Architectural Review Board Staff Report

Description: **Chesterfield Valley Nursery SDP:** A Site Development Plan, Landscape Plan, Architectural Elevations and Architectural Statement of Design for a 54.97-acre tract of land located along the north side of North Outer 40 Road and east of Boone's Crossing (17T620041).

Figure 4: Color Site Plan

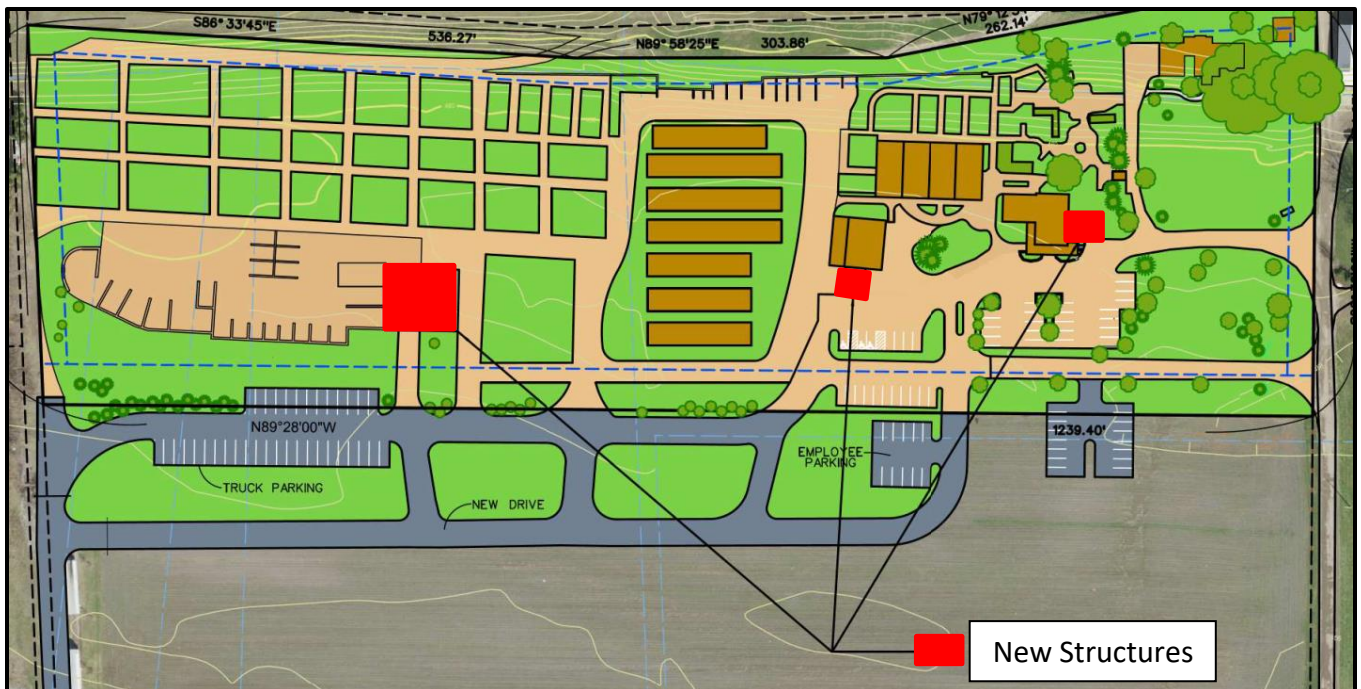
The site is accessed only from North Outer 40 Rd. by a single gravel drive into the site. Code requires that all parking and loading areas, including driveways, be paved. Exceptions can be made for both AG and NU districts if the City can approve an alternative dustproofing method. Gravel is not considered suitable dustproofing method as dust carries offsite onto adjacent properties. The Site Development Plan shows the gravel drive to remain in place in conjunction with this request.

Figure 5: Landscape Plan

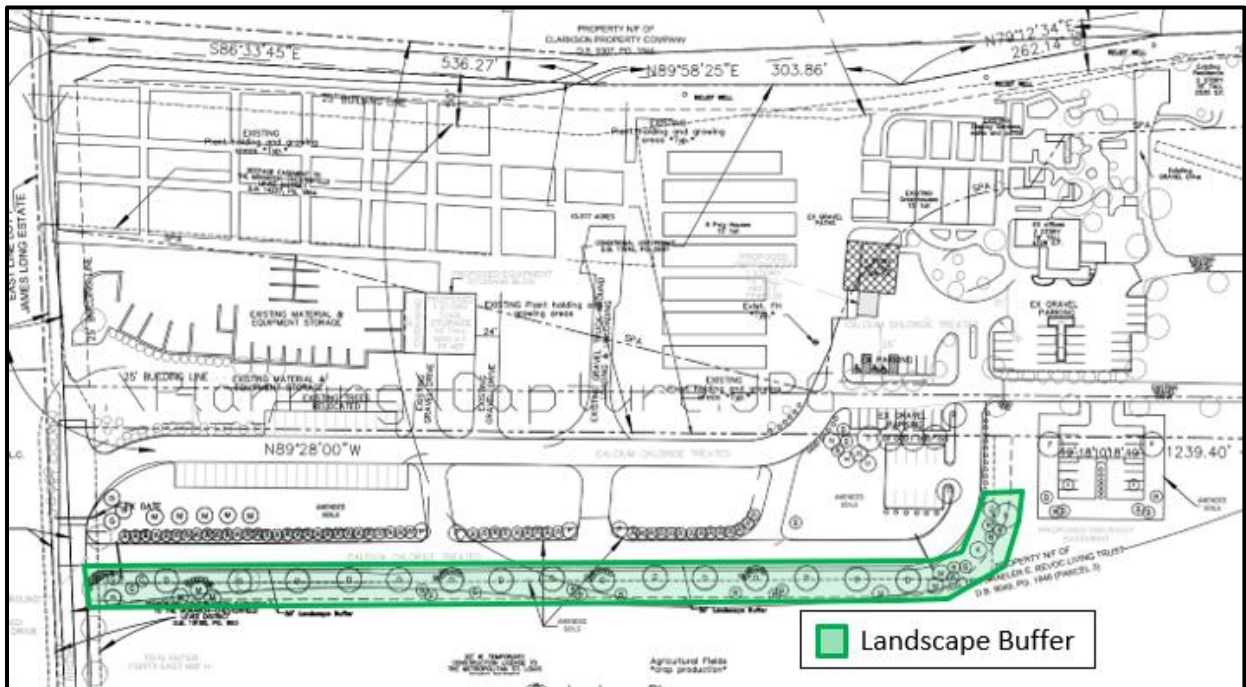
A landscape buffer is required along the south end of this development where the property abuts I-64 and North Outer 40 Rd. The Landscape Plan depicts a landscape buffer along the south side of the parking area and access drive into the site. Since the primary use on the site is a nursery, the inventory of trees and shrubs provides additional greenery throughout the site as well.
